ITEM FOR ENVIRONMENTAL BOARD AGENDA

NAME & NUMBER OF PROJECT: 3337 Far View Drive
SP-2014-0135D

REQUEST: To modify the standard 150-foot width Critical Environmental Feature buffer in order to allow construction of a tram 10 feet wide and 420 feet long that spans 2 canyon rimrocks and a seep within a Critical Environmental Feature (rimrock and seep) buffer corridor, 25-8-281(C)(2)(b).

Variance Request: Variance from LDC 25-8-281(C)(2)(b) Construction within a Critical Environmental Buffer Zone.

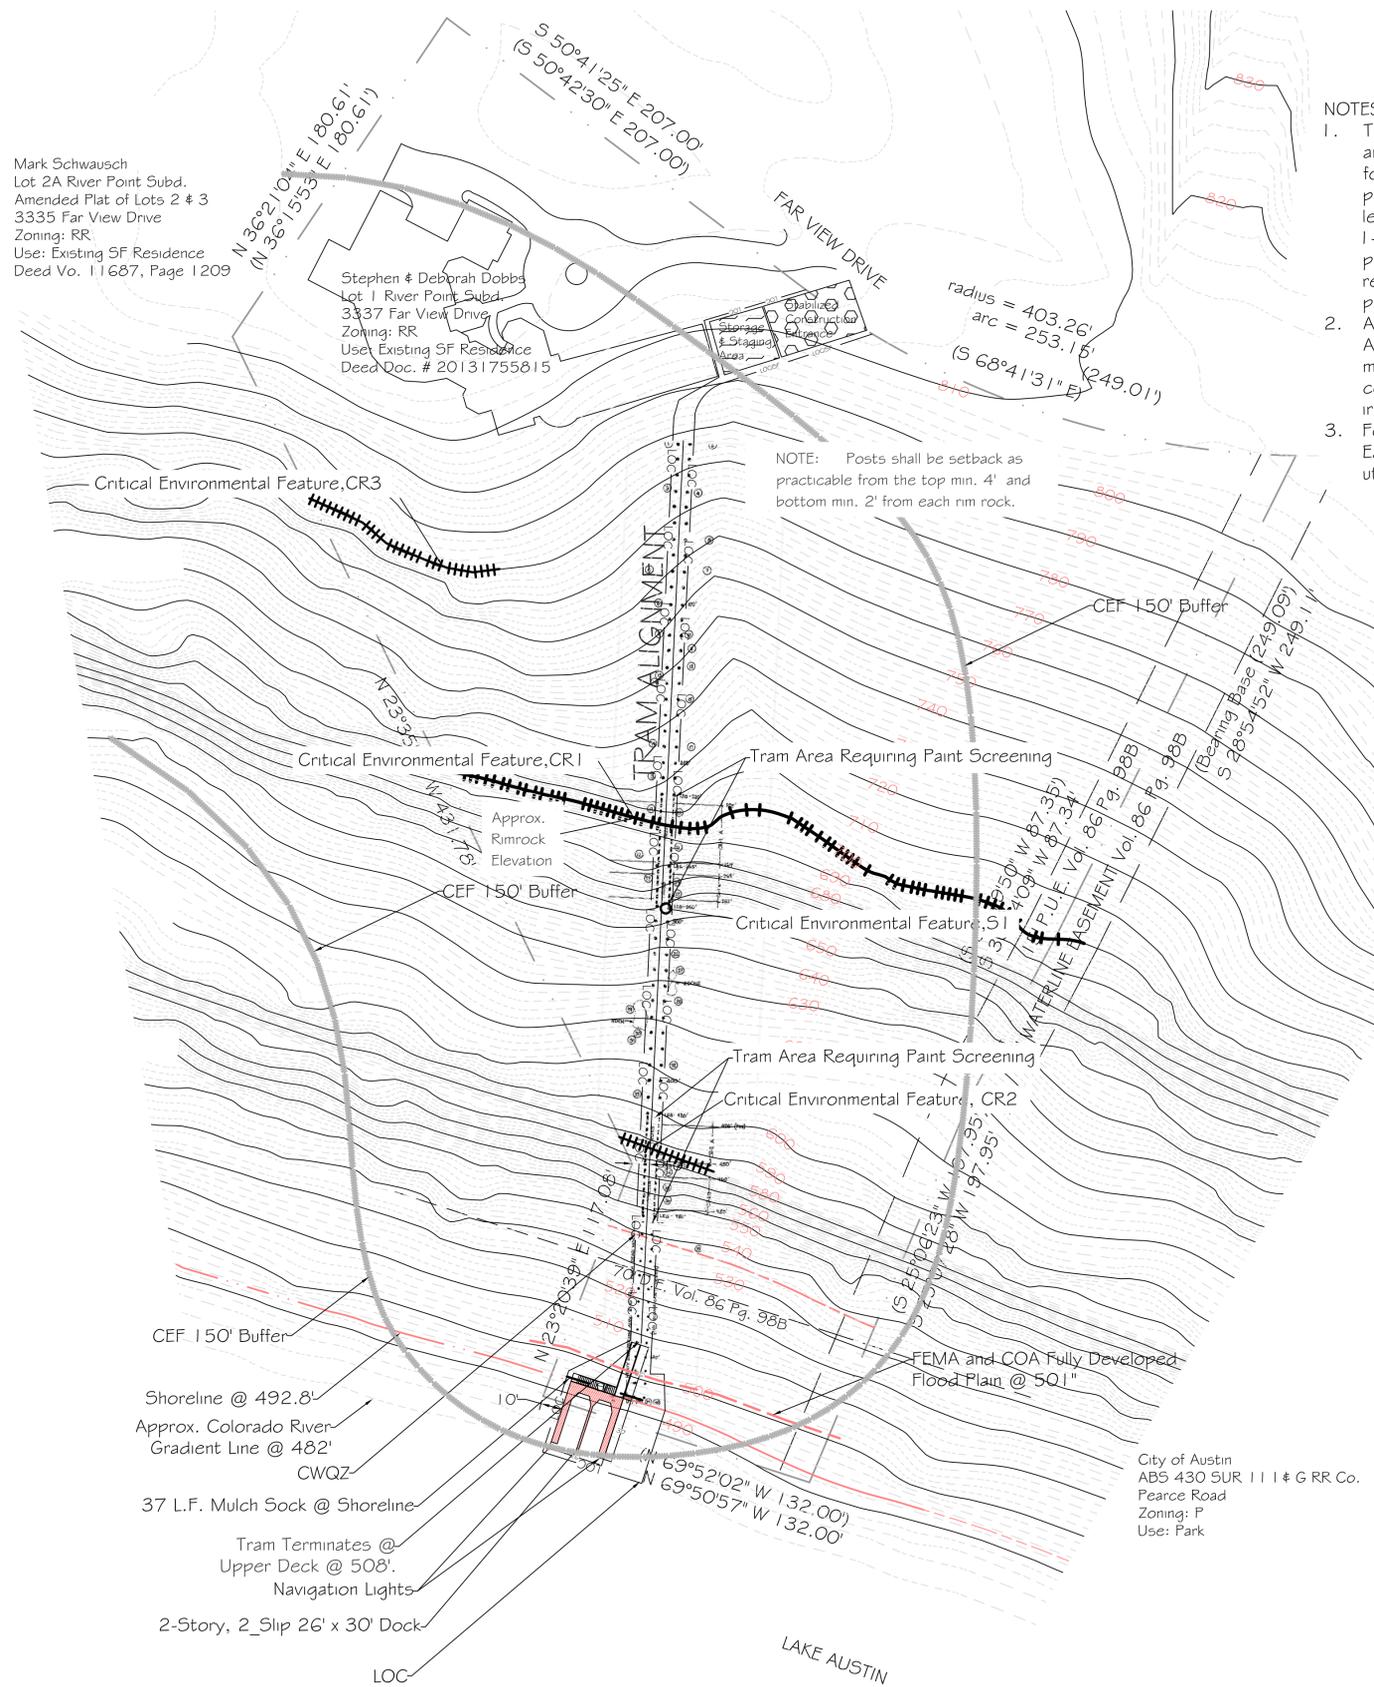
STAFF RECOMMENDATION: Recommended, with the following conditions:

1. Per the recommendations of the geotechnical engineer, (MLAW Forensics, Inc.), footing holes should not be drilled into the limestone rock if an obvious fracture exists running through the proposed drill location; and

2. A footing-separation distance of 1 foot above and 2 feet below the canyon rimrock CEF will be observed.

NOTE: Posts shall be setback as practicable from the top min. 4' and bottom min. 2' from each rim rock.
